ADDENDUM NO. 3

DATE: August 27, 2024
FROM: City of Grand Junction Purchasing Division
TO: All Offerors
RE: Sewer Replacement 12th Street and Wellington Avenue IFB-5487-24-DD

12TH ST AND WELLINGTON AVE SEWER REPLACEMENT

C2.1

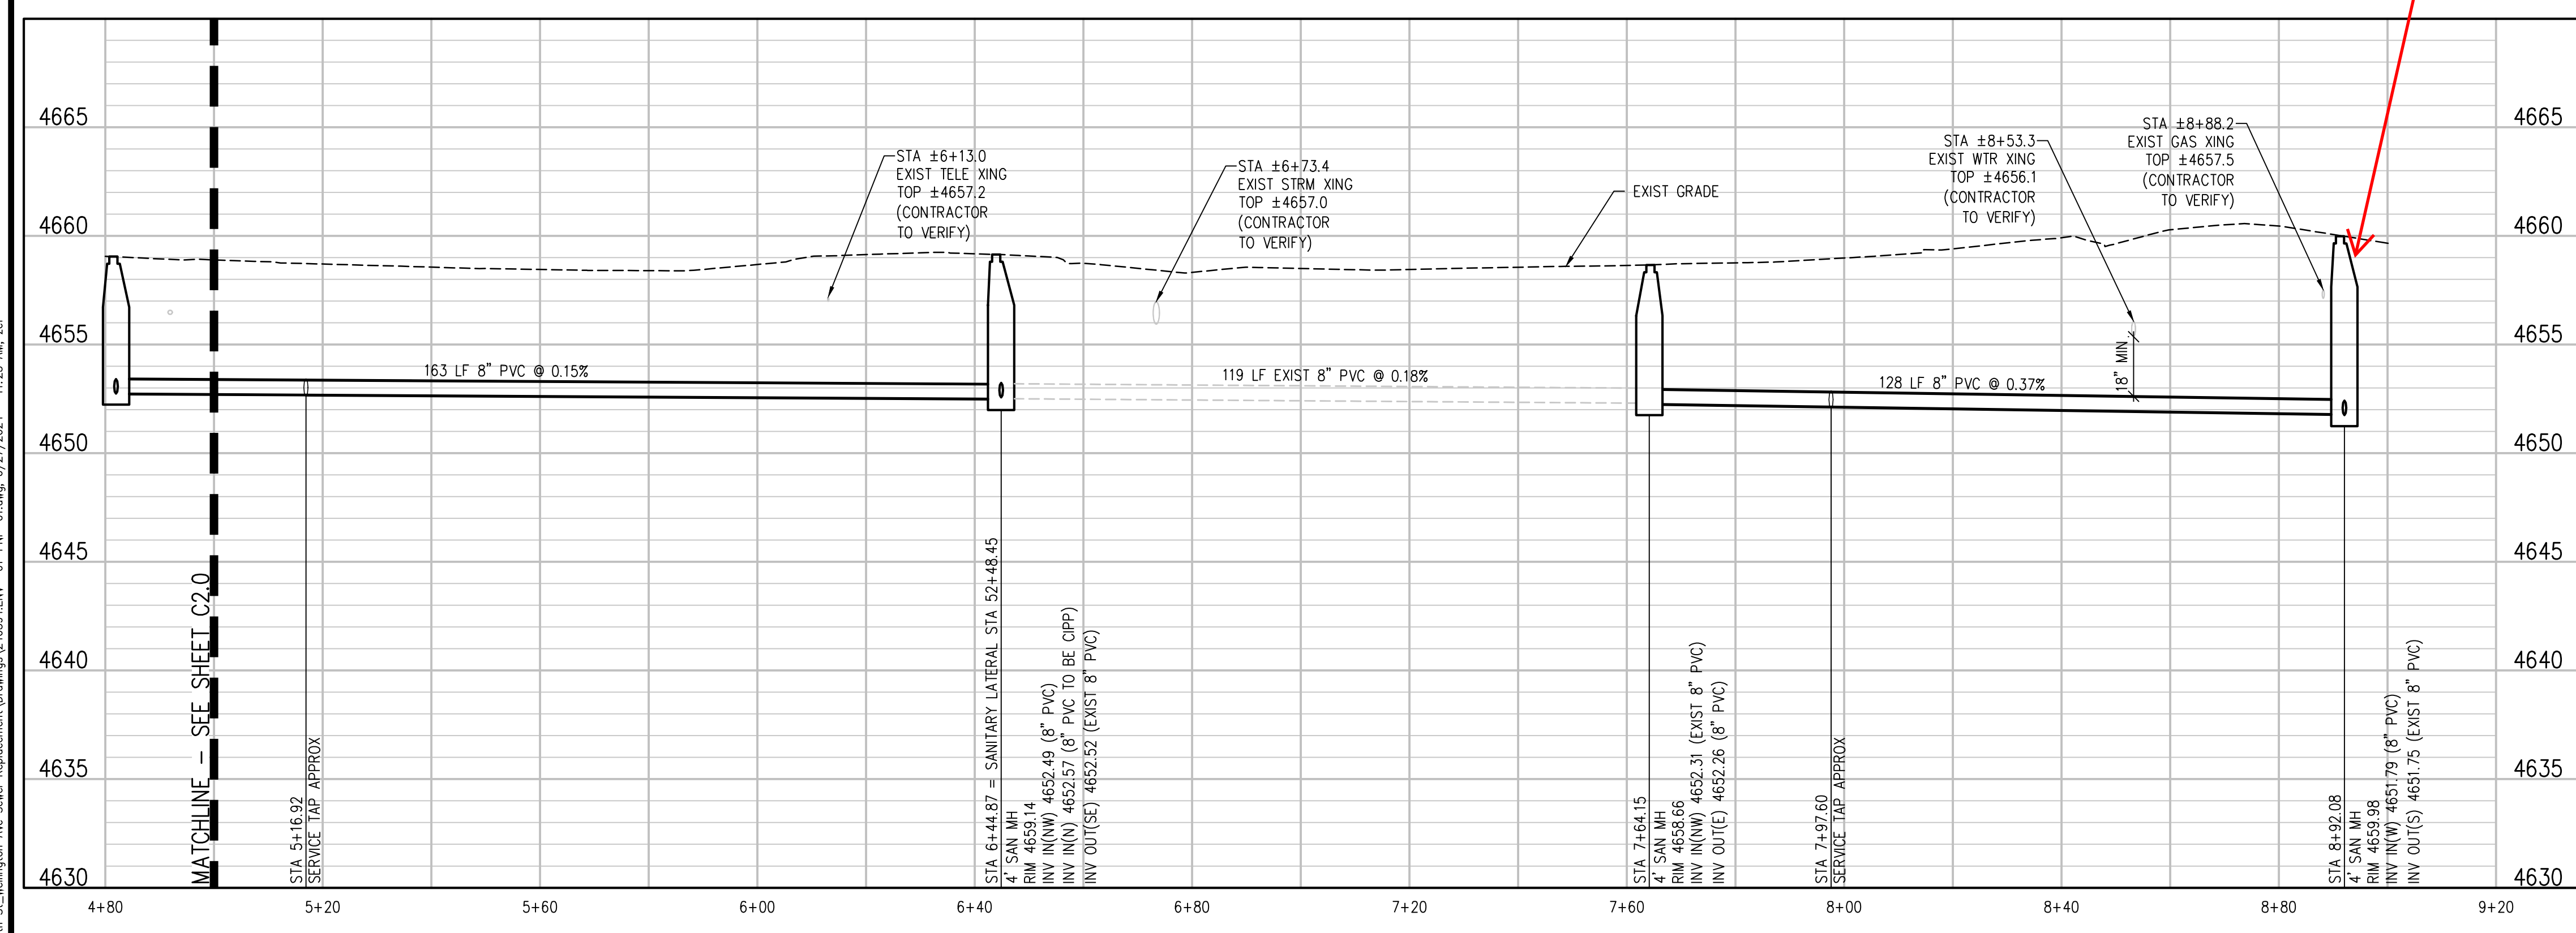
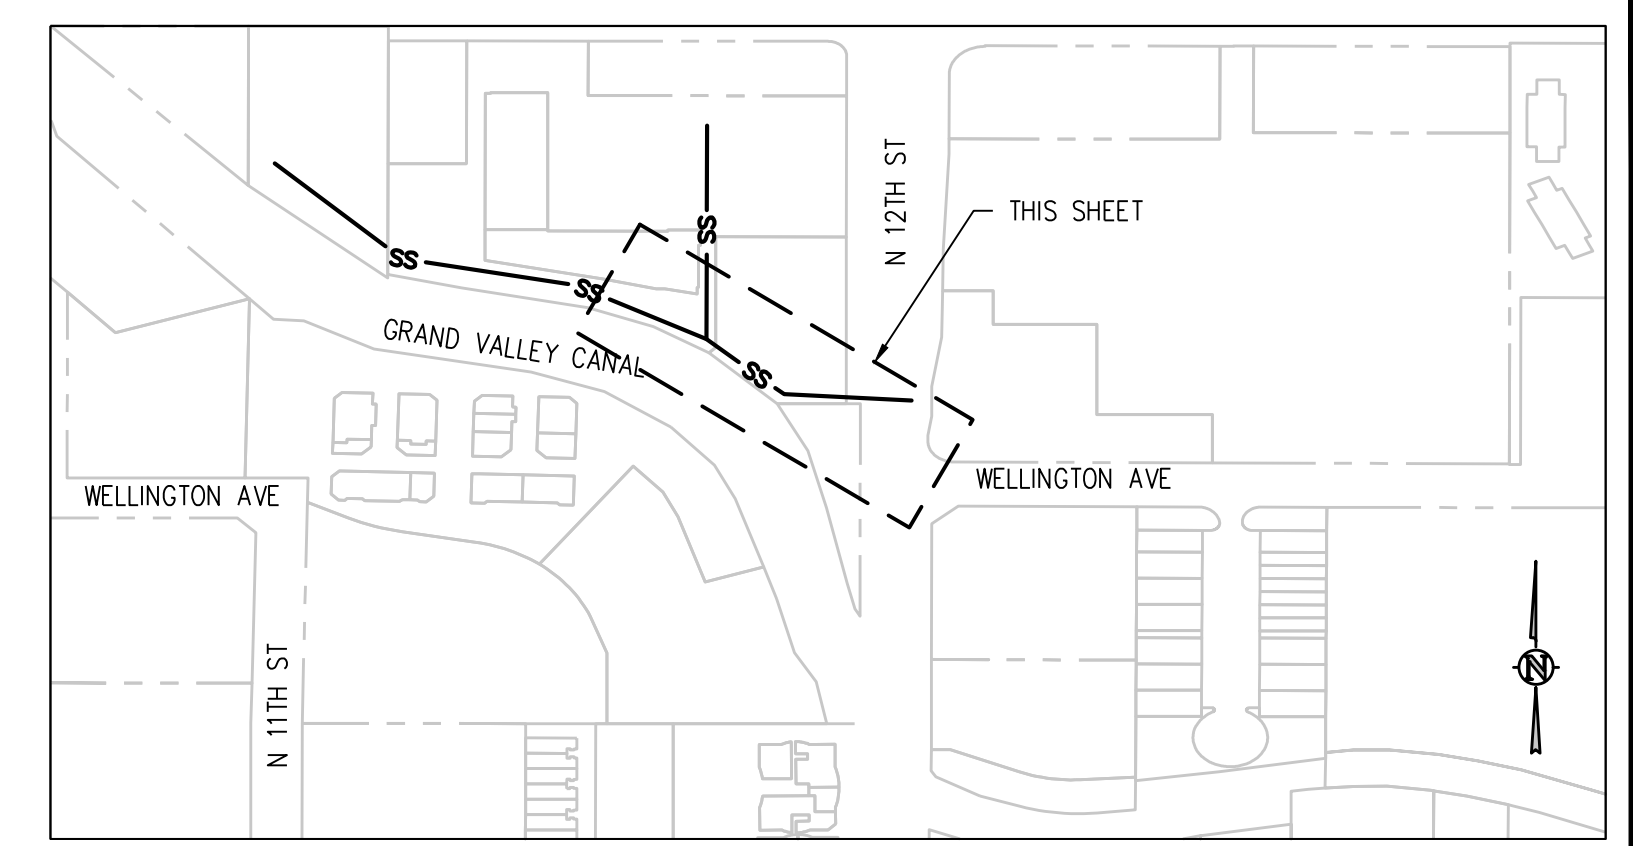
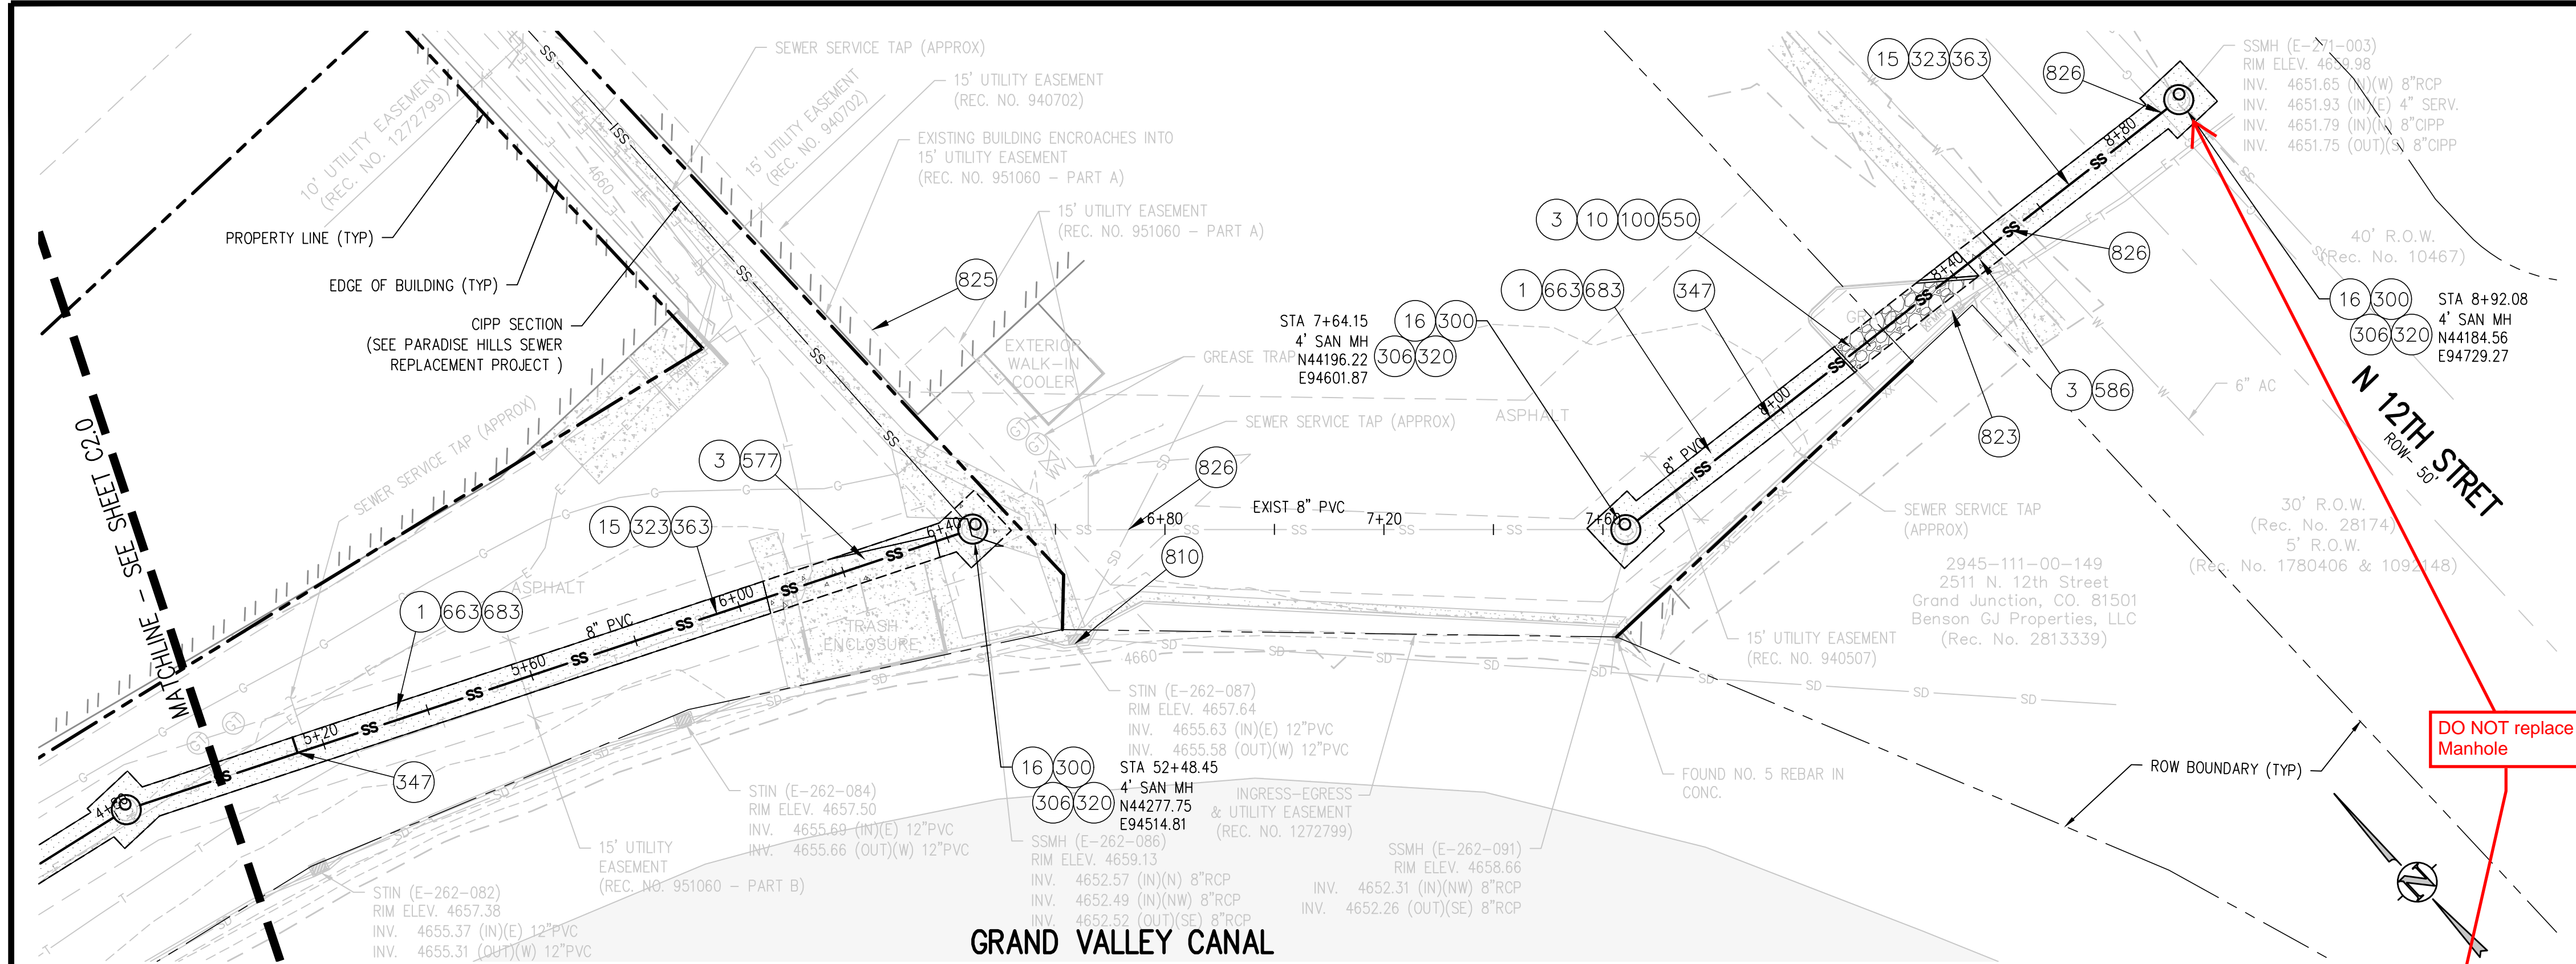
- Flow rate in manhole in 12th street estimated to be half full
- Updated Bid sheet attached. **Please use when submitting your bid.**
 - Includes spot repair line item
- Updated drawing sheet set
 - Include spot repair
- Confirm replace MH in 12th Street?
 - DO NOT REPLACE Manhole in 12th street

DO NOT replace Manhole

PARADISE HILLS
SANITARY SEWER CIPP
12TH ST & WELLINGTON AVE CIPP
PLAN AND PROFILE

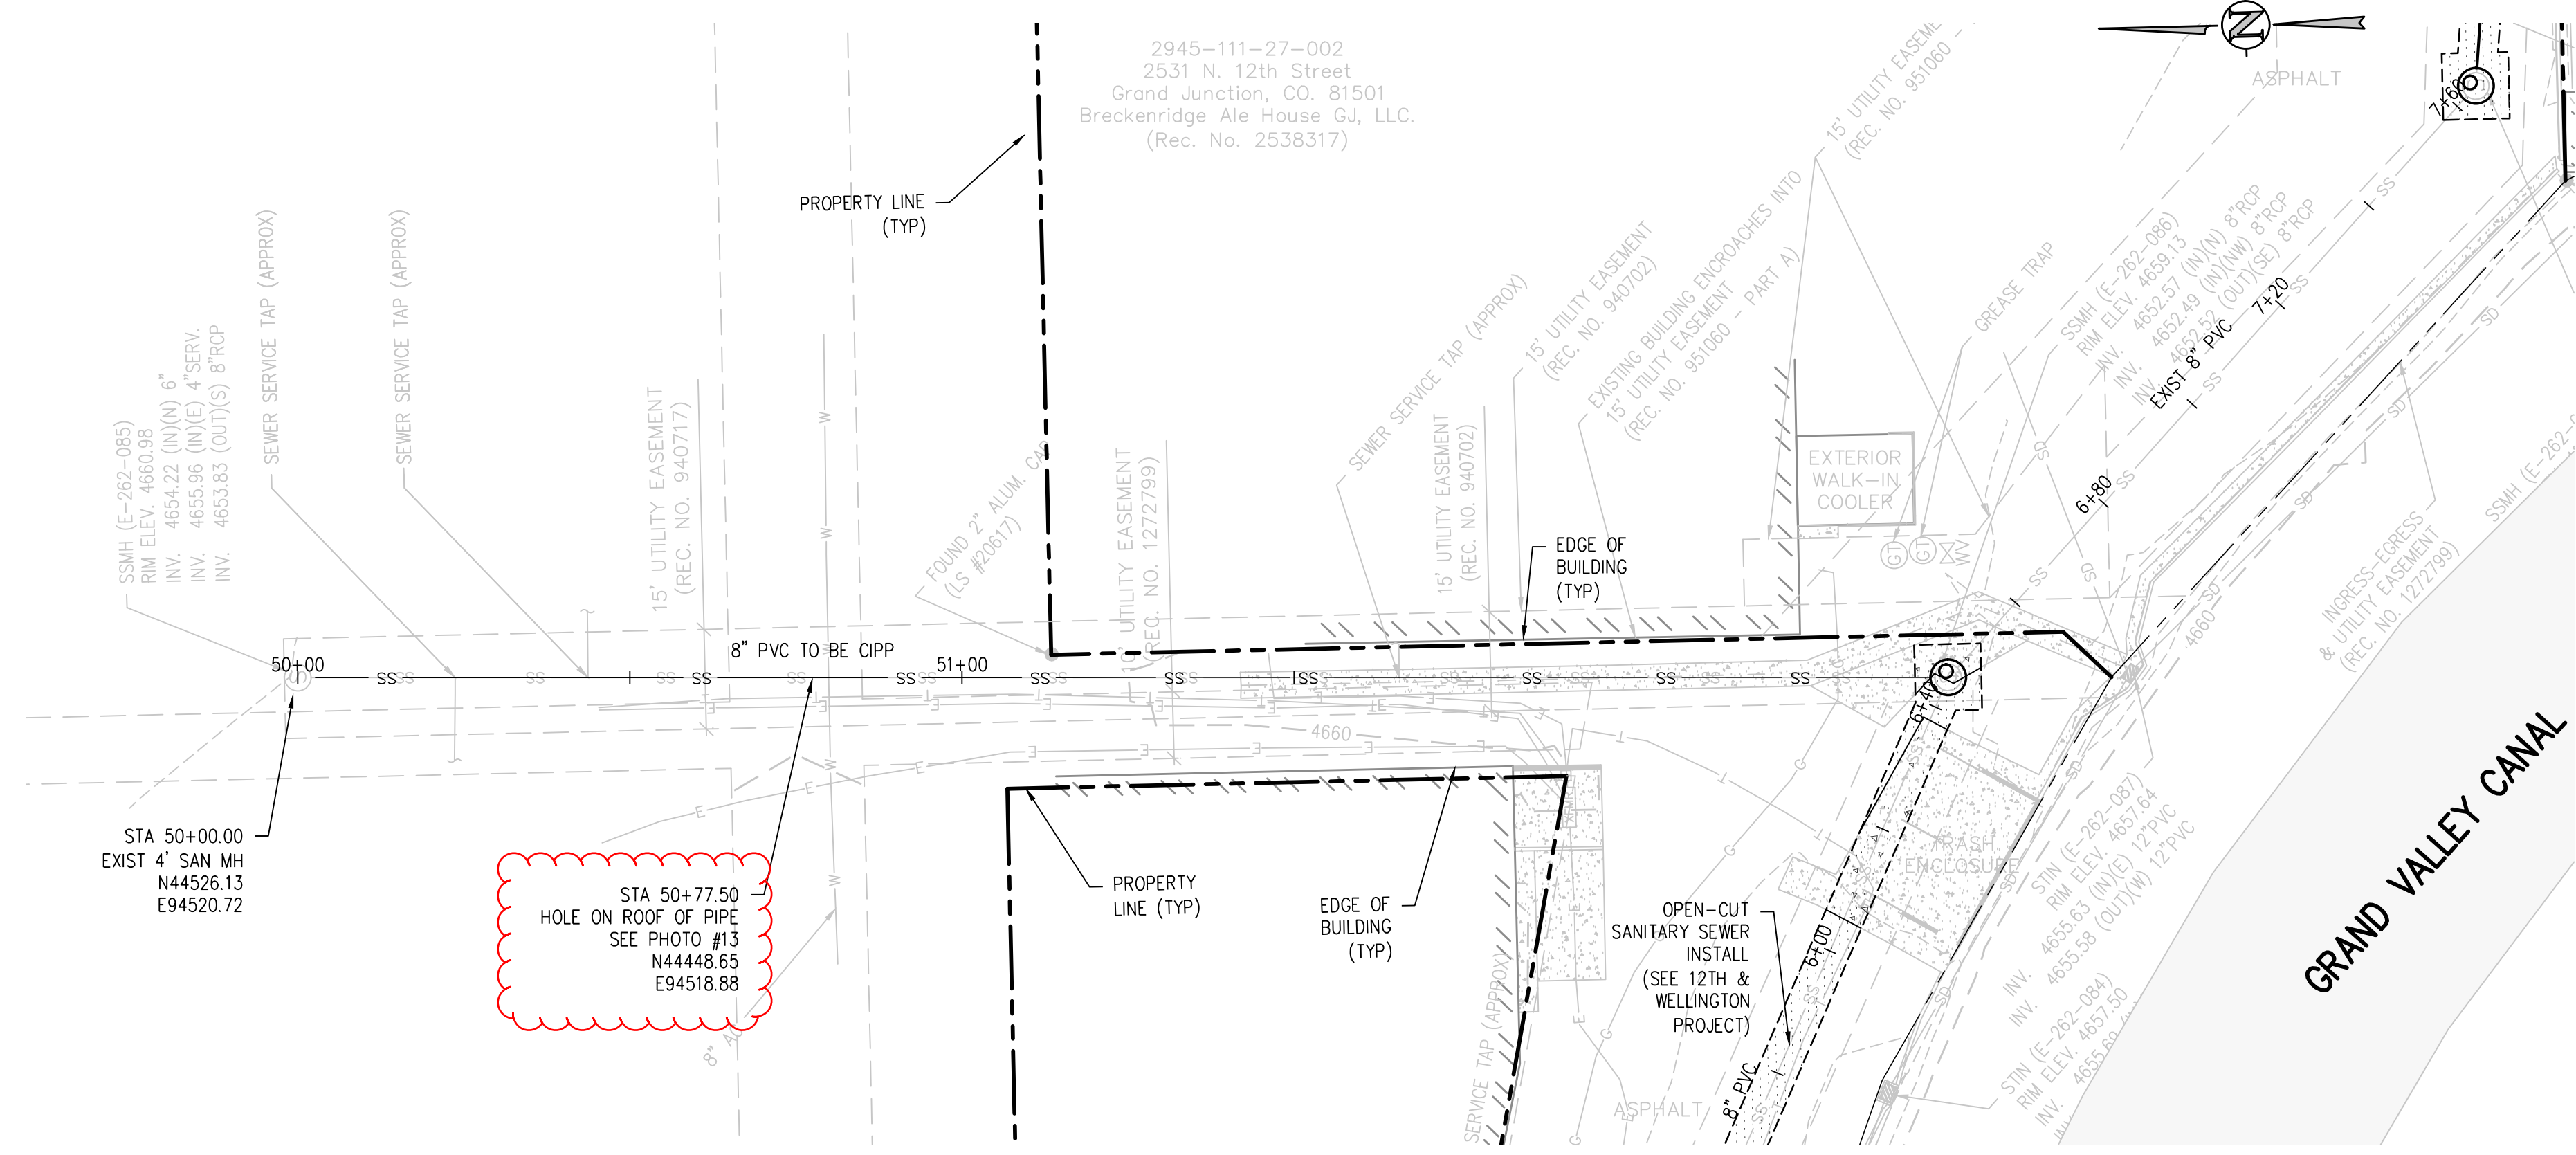
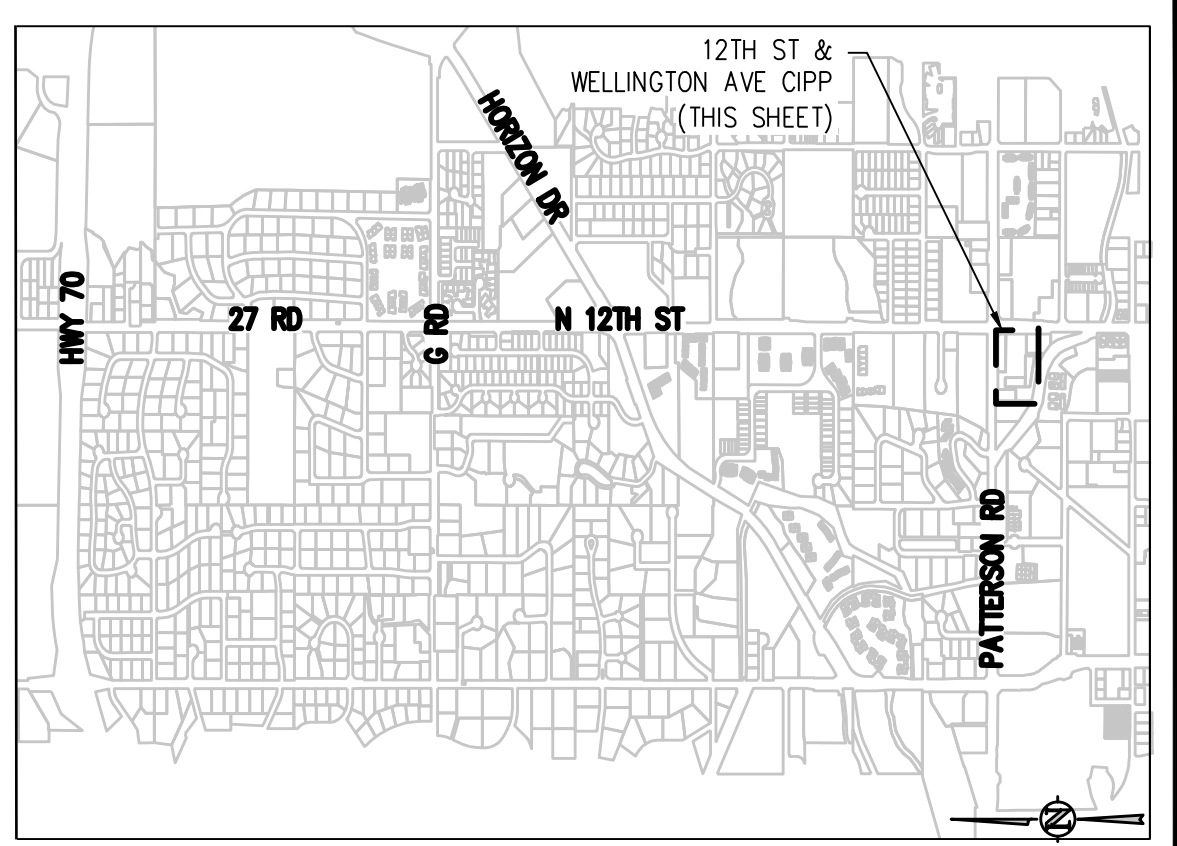
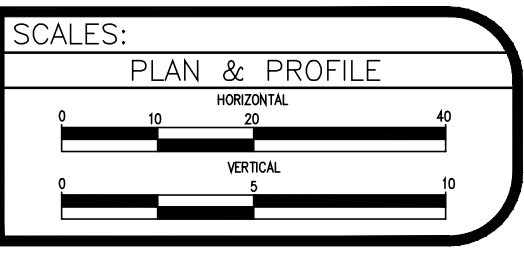
25	626	Mobilization	1	LS	\$ _____	\$ _____
26	630	Traffic Control (Complete in Place)	1	LS	\$ _____	\$ _____
27	108.2	Spot Repair - Parking Lot page C1.5	1	LS	\$ _____	\$ _____
28	MCR	Minor Contract Revision	1	LS		\$60,000.00
			Bid Amount:		\$ _____	
Written Bid Amount: _____						Dollars

ADDENDUM #3 ADD SPOT REPAIR PAGE C1.5
change Manhole Quantity for replacement
